September 23, 1996

RESPONSE TO OBSERVATIONS DATED
AUGUST 27, 1996

RESPONSE TO OBSERVATIONS DATED
SEPTEMBER 5, 1996

Subject: DEVICE REVIEW

LA-B-009

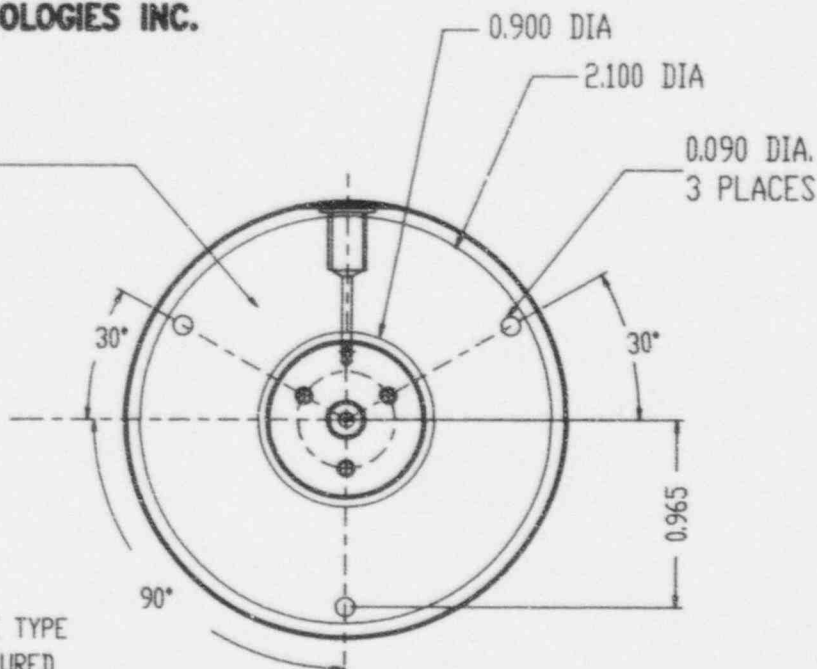
The parts list and their applicable drawings are included here. Your attention is drawn to drawing number IM-B-040 note 1, that makes reference to the tamper proof screws, and drawing number LA-B-009 that shows the location of the label on the IMS.

4. Per our conversation on September 3, you stated that the label on the detector will have the information engraved in the aluminum. Your letter did not address this. Please verify how the information will be applied to the label.

My fax stated at para 6 that the label will be made from aluminum plate 20 thousands thick, and secured to the device with screws or rivets.

NOTE: THE LABEL WILL BE A NON-ADHESIVE TYPE WITH THE RADIATION SYMBOL AND TEXT COLOURED MAGENTA ON A YELLOW BACKGROUND.

LA-B-007

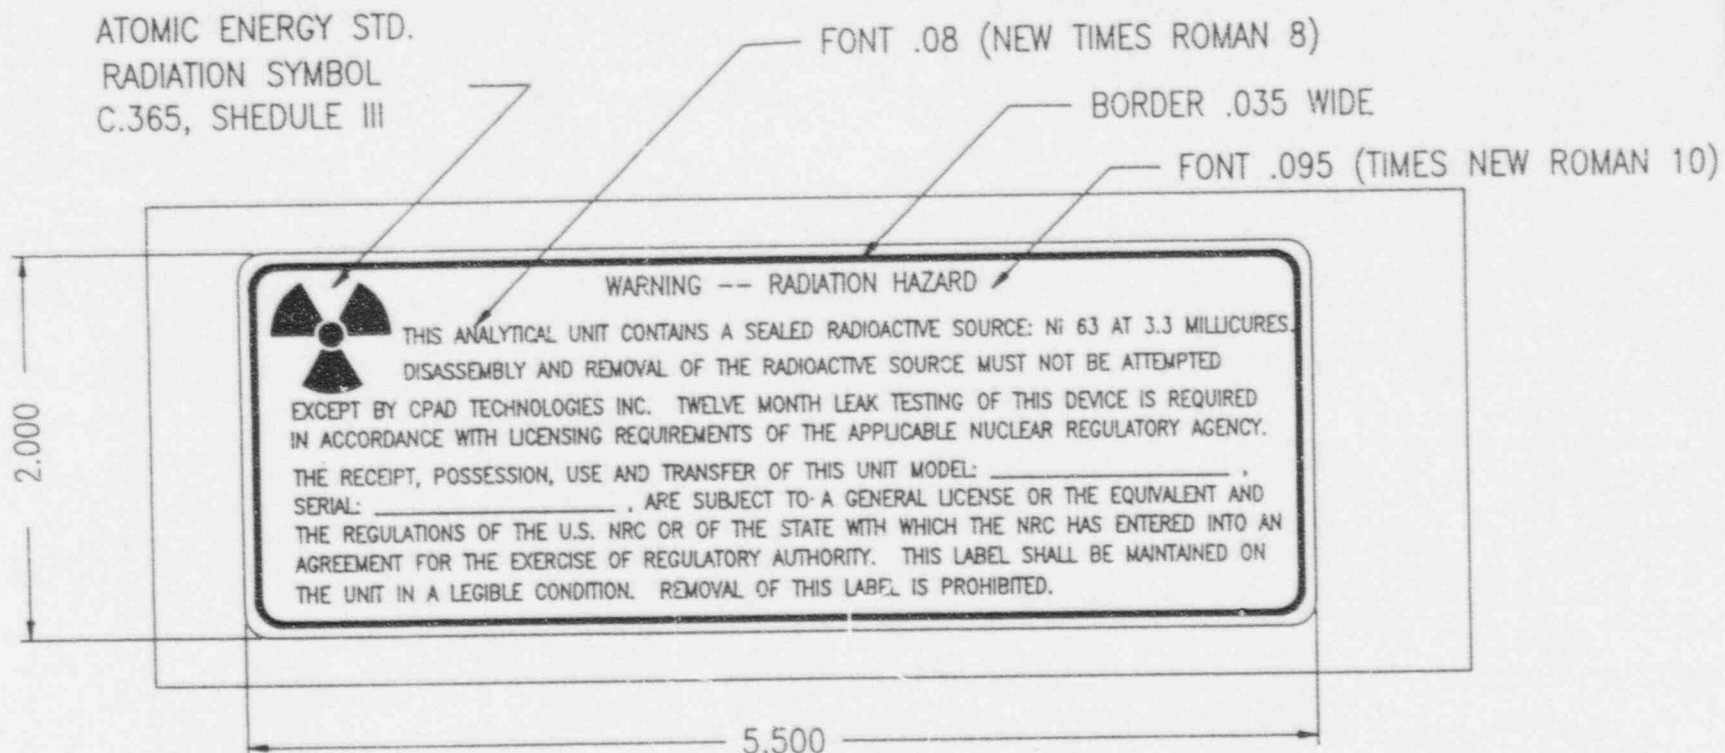
5. What material will be used for the label attached to the analytical unit? In addition, what adhesive will be used to attach this label to the analytical unit?

The label selected for this application is a number 468 "SCOTCH" Brand Adhesive Transfer Tape. The information on the construction is that the adhesive is firm acrylate--0.004 inch, and the liner is silicone release-treated paper--0.004 inch. It meets MIL-P-6906A amendment 1, and the adhesive requirements of MIL-P-19834A, Type 1. Of main concern in this application is the temperature, and the claim from the 3M Company is that "when properly applied to suitable substrates this adhesive is serviceable when exposed to temperatures up to 400 degrees F".

NOTE : THE LABEL WILL BE AN ADHESIVE TYPE.
WITH THE RADIATION SYMBOL AND TEXT COLORED
MAGENTA ON A YELLOW BACKGROUND

LA-B-009

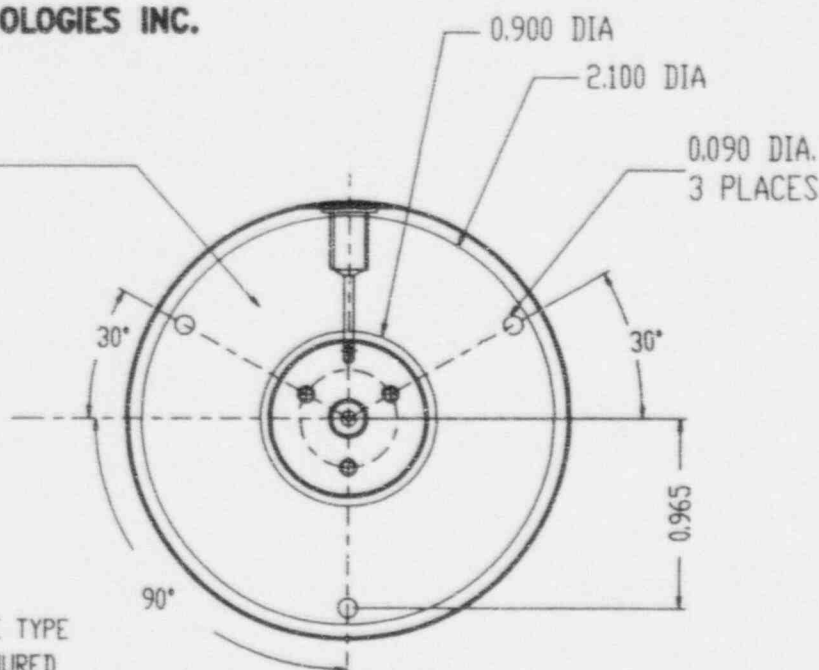
4. Per our conversation on September 3, you stated that the label on the detector will have the information engraved in the aluminum. Your letter did not address this. Please verify how the information will be applied to the label.

My fax stated at para 6 that the label will be made from aluminum plate 20 thousands thick, and secured to the device with screws or rivets.

NOTE: THE LABEL WILL BE A NON-ADHESIVE TYPE
WITH THE RADIATION SYMBOL AND TEXT COLOURED
MAGENTA ON A YELLOW BACKGROUND.

LA-B-007

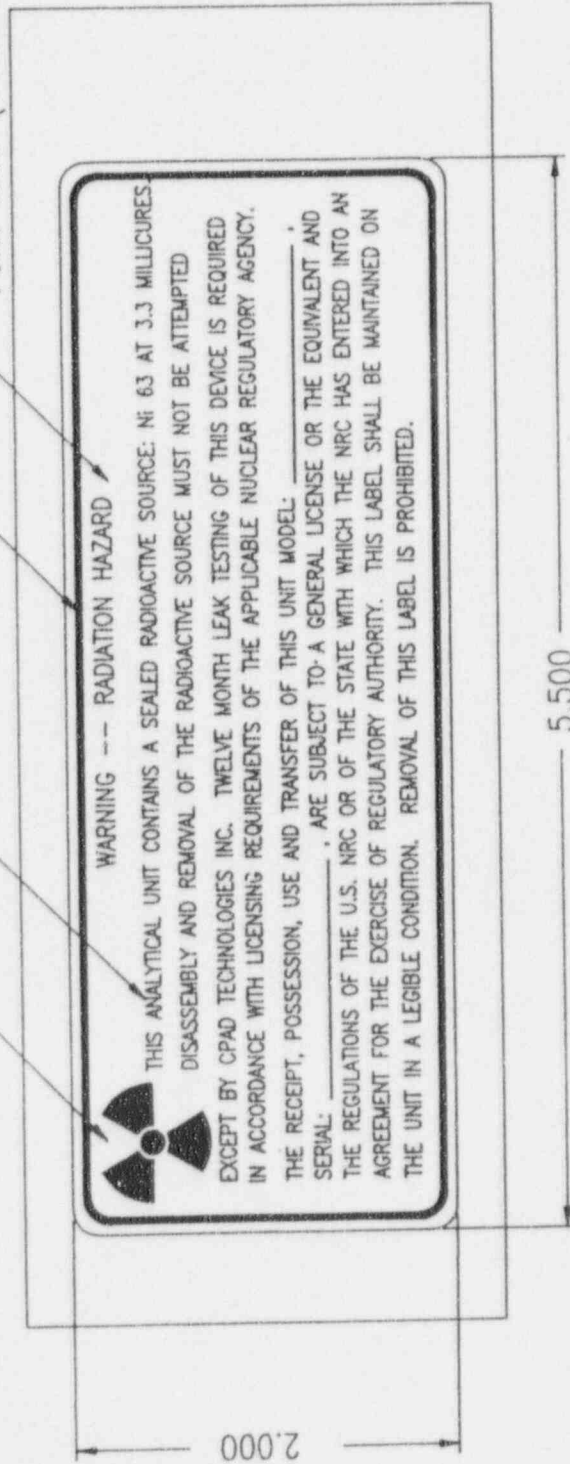
5. What material will be used for the label attached to the analytical unit? In addition, what adhesive will be used to attach this label to the analytical unit?

The label selected for this application is a number 488 "SCOTCH" Brand Adhesive Transfer Tape. The information on the construction is that the adhesive is firm acrylate—0.004 inch, and the liner is silicone release-treated paper—0.004 inch. It meets MIL-P-6906A amendment 1, and the adhesive requirements of MIL-P-19834A, Type 1. Of main concern in this application is the temperature, and the claim from the 3M Company is that "when properly applied to suitable substrates this adhesive is serviceable when exposed to temperatures up to 400 degrees F".

NOTE : THE LABEL WILL BE AN ADHESIVE TYPE.
WITH THE RADIATION SYMBOL AND TEXT COLORED
MAGENTA ON A YELLOW BACKGROUND
